Access Compliance Report

Public Rights-of-Way

Intersection ID: 27197	Main Street: BALLANTYNE_COMMONS_PY	Cross Street: CRESTWOOD_DR	Location: NW
ADA ID: 067A04CE7868	Ramp Type: Perp	Initial Pass/Fail: Fail	Overall Compliance: No
Severity Score: 33.75			
Codes/Mitigation Info/Possible Solution		Field Measurements/Component Compliance

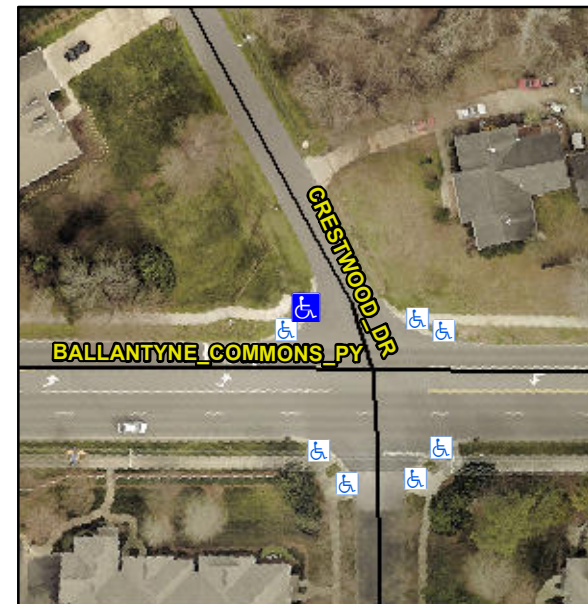
R304.5.1, R304.5.3

Compliance	Description	Data	Compliance	Description	Data
N/A	Ramp Length (in)	98.0	Yes	Ramp Slope (%)	4.3
No	Ramp Width (in)	47.0	No	Ramp XSlope (%)	9.1
N/A	Flare Type LT	N/A	N/A	Flare Type RT	N/A
N/A	Flare Slope LT (%)	N/A	N/A	Flare Slope RT (%)	N/A
N/A	Flare Traversable LT?	N/A	N/A	Flare Traversable RT?	N/A
N/A	Landing Length (in)	N/A	N/A	DWS Provided?	N/A
N/A	Landing Width (in)	N/A	N/A	DWS Contrast?	N/A
N/A	Landing Slope (%)	N/A	N/A	DWS Length (in)	N/A
N/A	Landing X Slope (%)	N/A	N/A	DWS Full Width?	N/A
N/A	Landing Curb? (Y/N)	N/A	N/A	DWS Offset (in)	N/A
N/A	Shared Landing?	N/A			
N/A	Gutter Ponding?	N/A	N/A	Gutter Slope (%)	N/A
N/A	Gutter Lip Ht (in)	N/A	N/A	Gutter X Slope (%)	N/A
N/A	Painted X Walk1?	No	N/A	Painted X Walk2?	N/A
	X Walk 1 Direction	To SE		X Walk 2 Direction	N/A
N/A	X Walk 1 Width (in)	N/A	N/A	X Walk 2 Width (in)	N/A
	X Walk 1 Slope (%)	5.7		X Walk 2 Slope (%)	N/A
	X Walk 1 X Slope (%)	9.7		X Walk 2 X Slope (%)	N/A

Remove & Replace Entire Ramp.
